ACRS-1694

MINUTES OF THE ACRS SUBCOMMITTEE
ON THE FLOATING NUCLEAR PLANT
LOS ANGELES, CA
NOVEMBER 17, 1979

3.1 FNP Core Ladle Description, Configuration, and Structural Evaluation

ESTIMATED CONTAINMENT BOUNDARY FAILURE PRESSURES-(PSI)

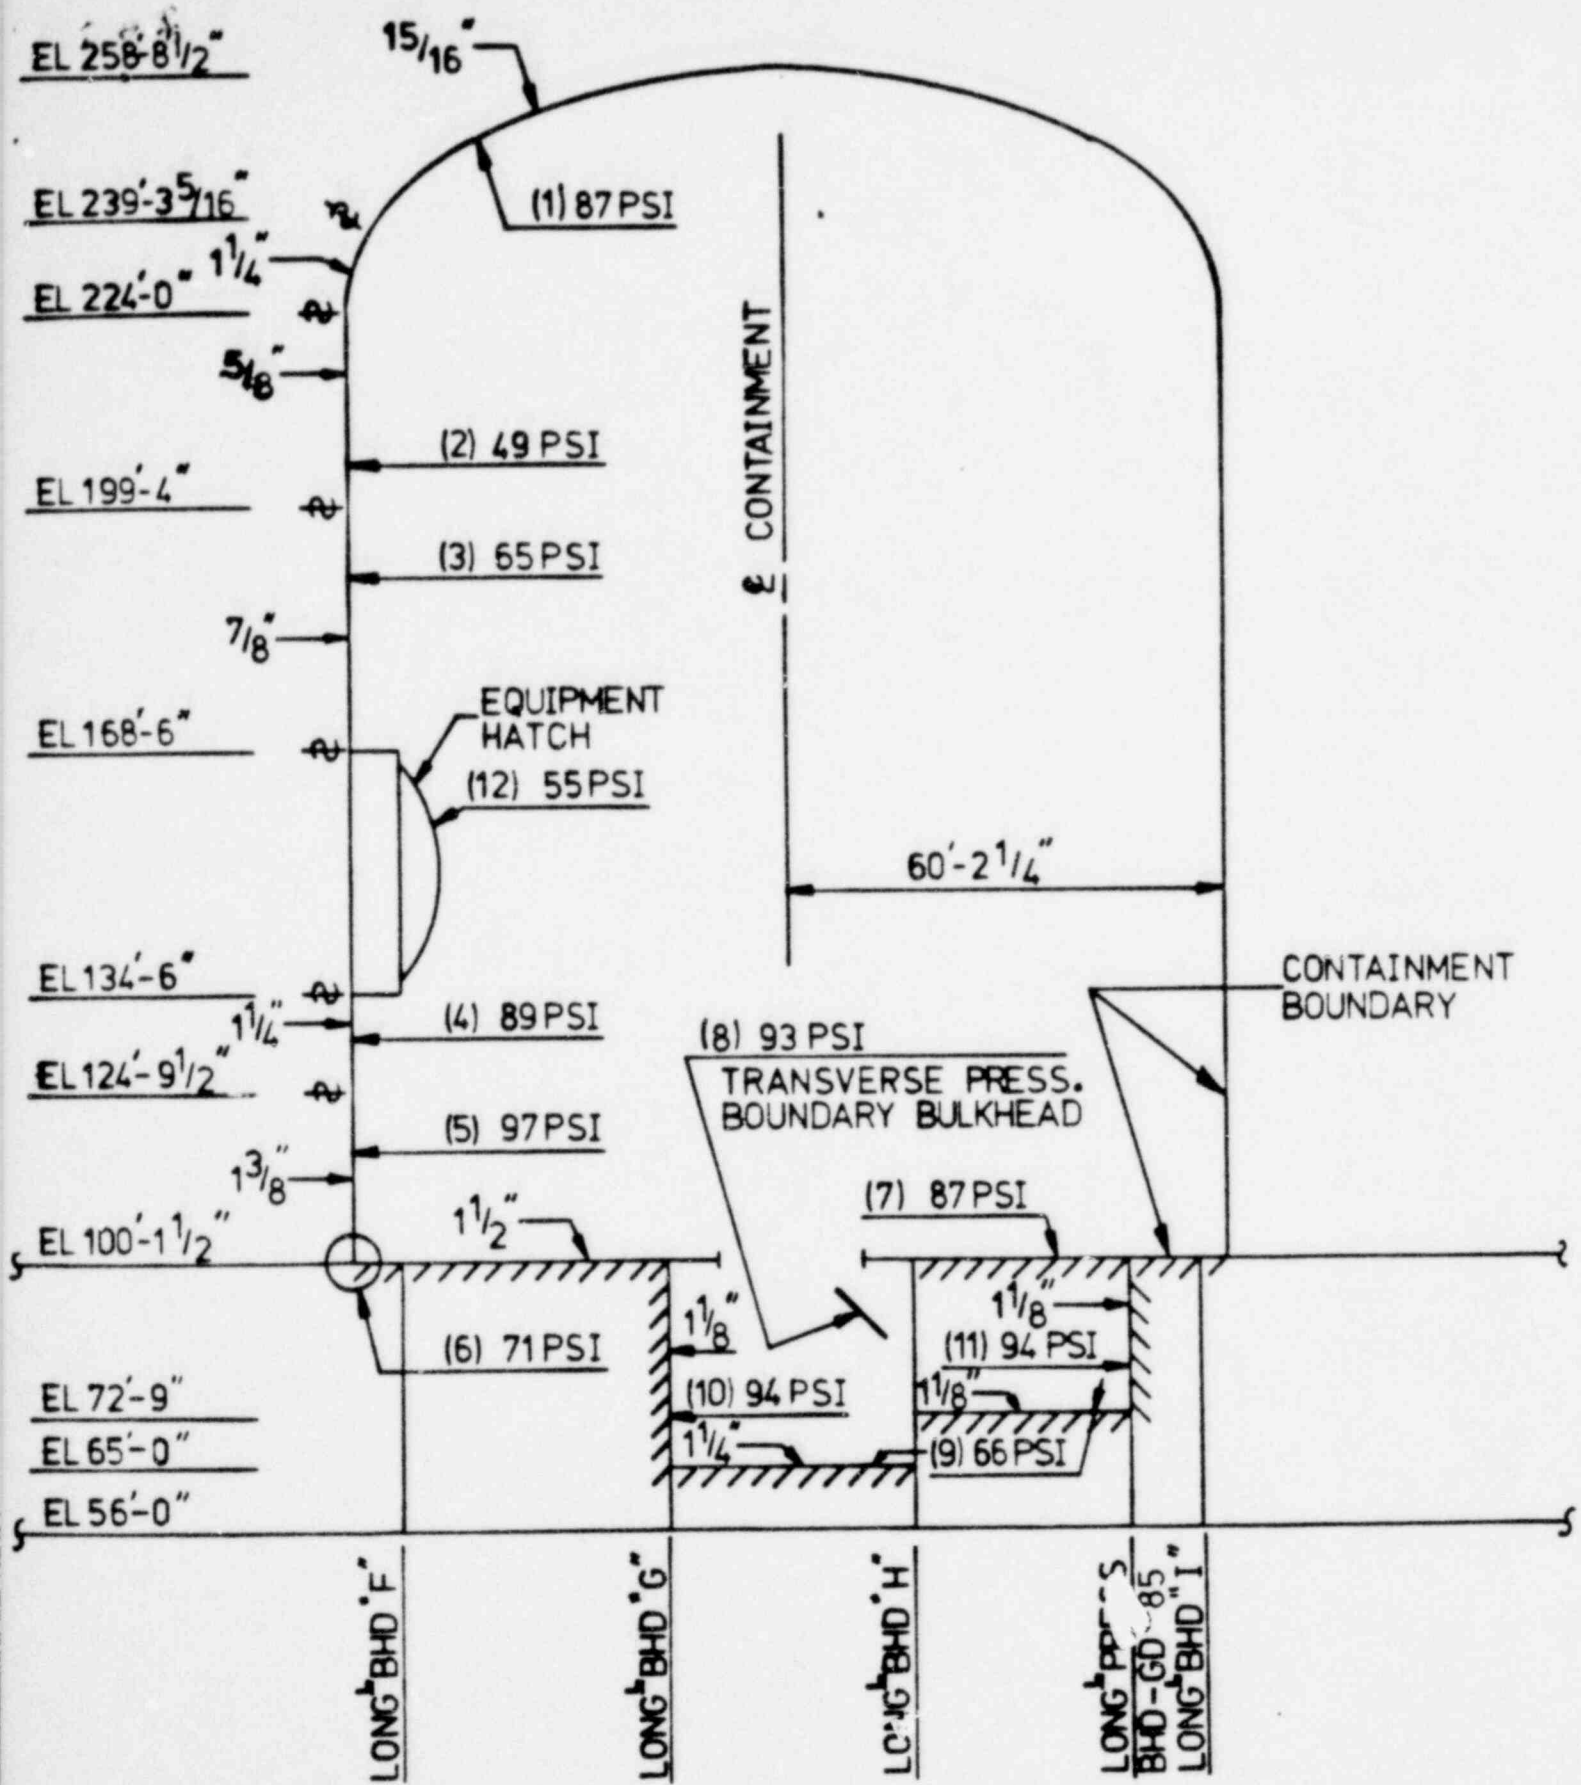
- o In a TMI type event the calculated containment pressure would be in the range of 35 to 40 psig. Estimated containment failure pressure is 49 psig (Attachment 25)
- o In a core melt accident with 100% Zr-H₂O reaction and with no hydrogen burn the calculated pressure is 40 psig.
- o In a core melt accident with hydrogen burn the pressure would reach about 200 psig which would exceed the estimated 49 psig failure pressure.
- o The electrical penetrations have a 60 psig design pressure and are not limiting in the FNP design.
- o Inerting the FNP ice condenser is feasible but totally impractical from the operators standpoint due to the frequent maintenance and inspection required. Present technical specifications of ice condensers require weekly walk-throughs. If things were properly

In response to questions from the Subcommittee it appeared that containment failure pressure could be increased from the existing 49 psi to about 65 psi by increasing the containment wall thickness from 5/8" to 7/8". Designing to a failure pressure above 65 psi would require some radical changes.

CONTAINMENT PRESS. RELIEF PIPING SECTION VIEW AT CONTAINMENT (COL.G.I) LOOKING TO BHD.H

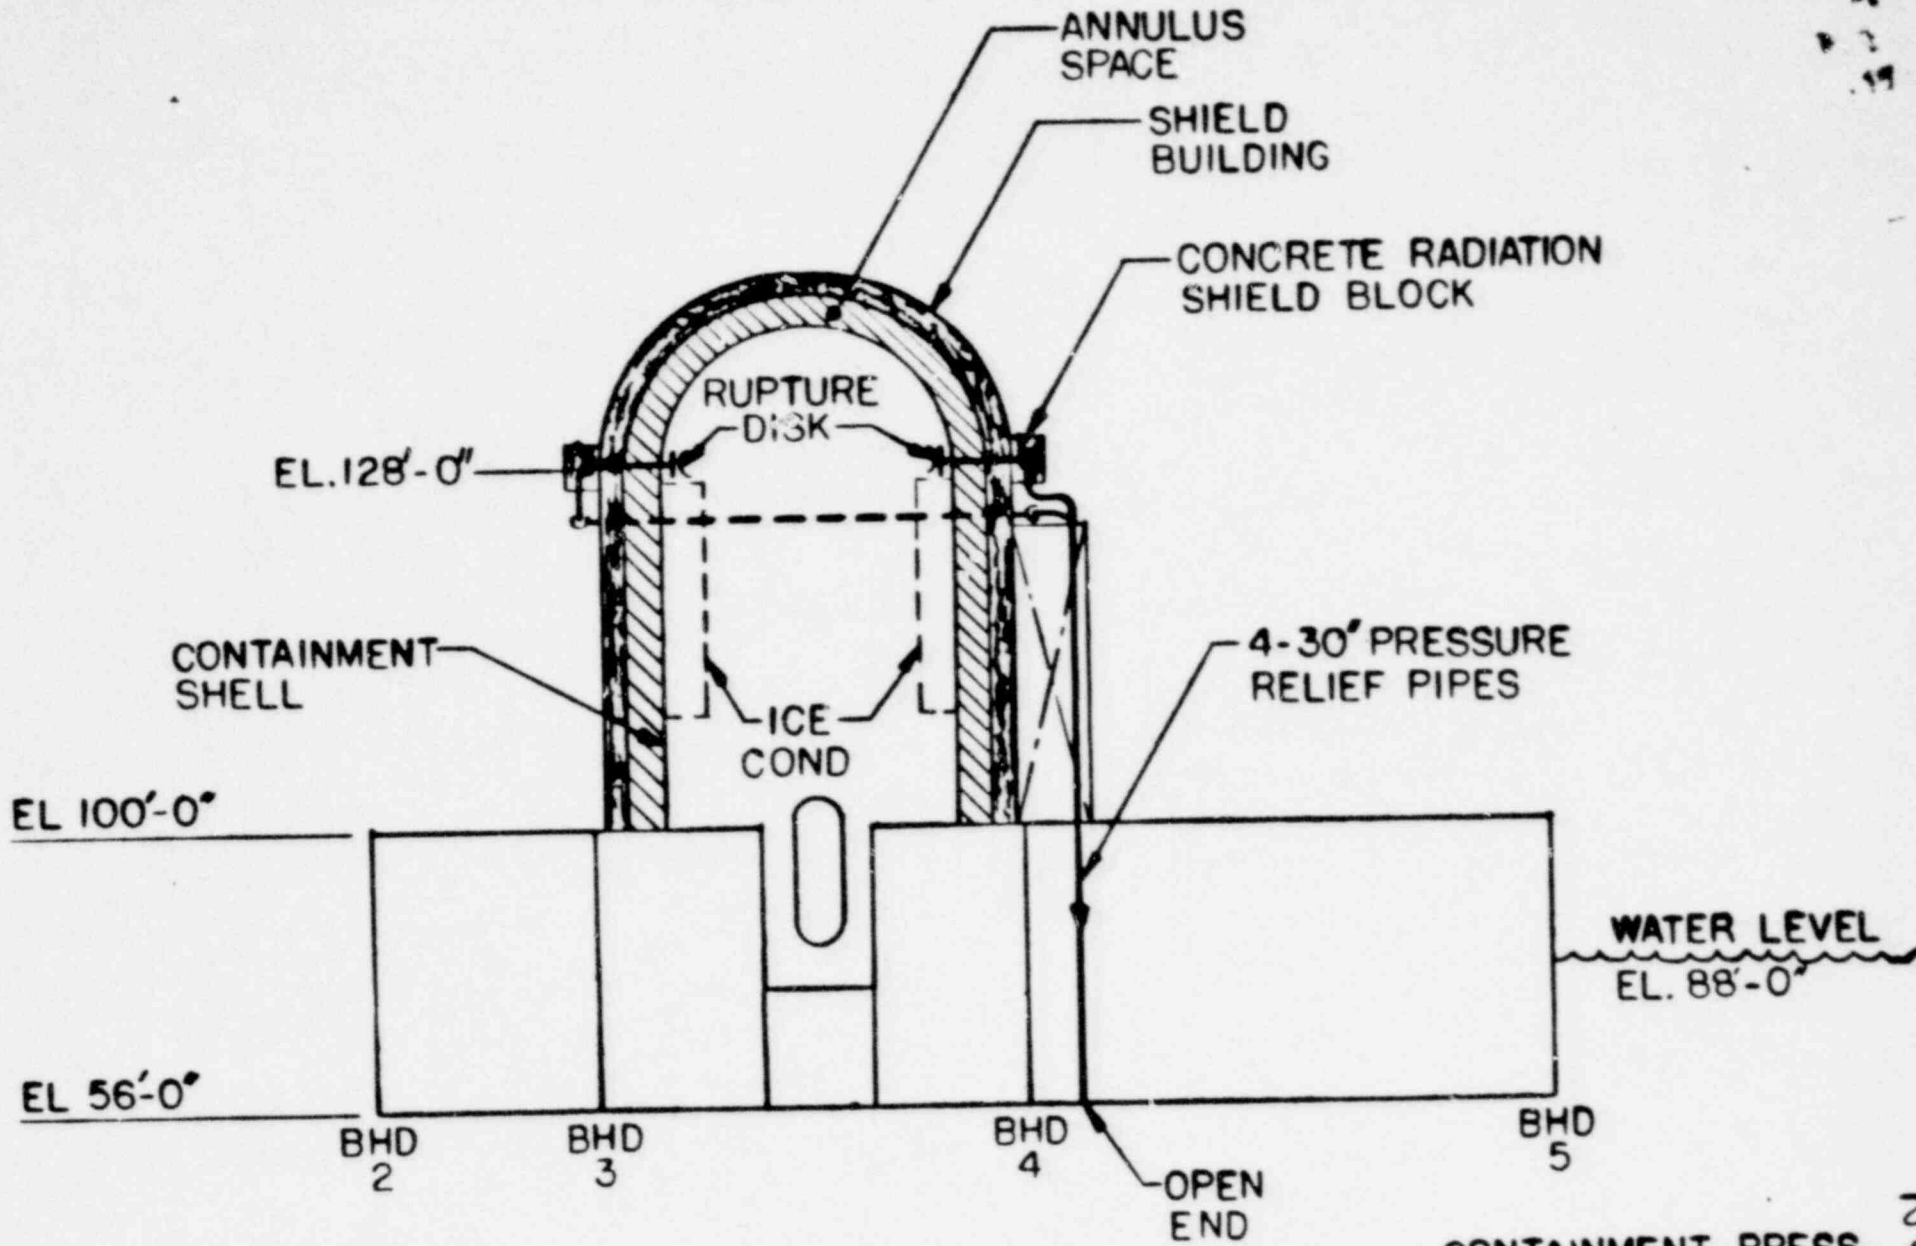
Dr. Walker discussed an FNP vented containment design concept which uses four 30-inch pipes that pass from the interior of the containment through the annulus space and down through the bottom of the platform (Attachment 26). The system is designed to pass 100,000 cu ft of gas per minute. The system would accommodate burning of the hydrogen generated by the zirc-water reaction in a period as short as five to ten minutes without exceeding 49 psi. The FNP design has flexibility and space available to accommodate this system if NRC rulemaking shows that it is required.

Mr. Mathis questioned the advisability of the concept of venting the containment to the sea.
